## WP-25-22

Re: 25-22W – 124 Lake Street – Patriots Park

Review Memorandum

Re: Response to Comments  
Application: WP-25-22  
STEAP Grant: Improvements to Patriots Park

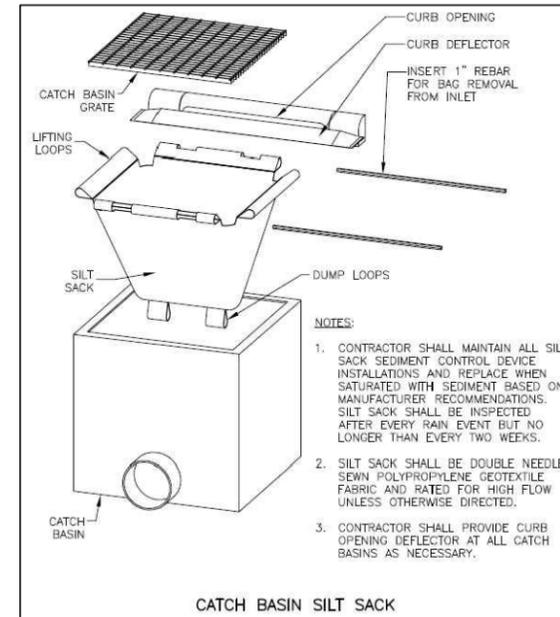
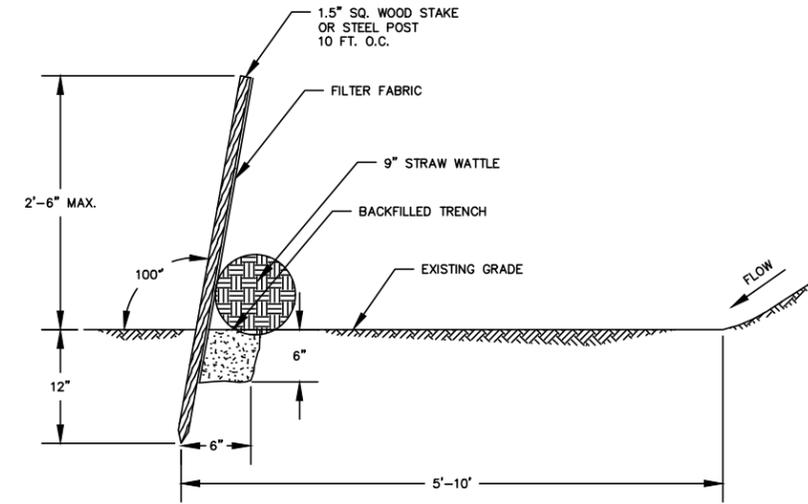
***In steep areas (over 8% slope) and areas within 50' of the lake, a double layer of E&S Controls should be installed per the current Connecticut Guidelines for Soil Erosion and Sediment Control. This can***

*consist of two lines of the same E&S Control, such as Silt Fence, or lines of two different E&S controls, such as silt fence combined with straw wattle.* The plans have been updated to call out the installation of 9” (minimum) straw wattle backed by silt fence.
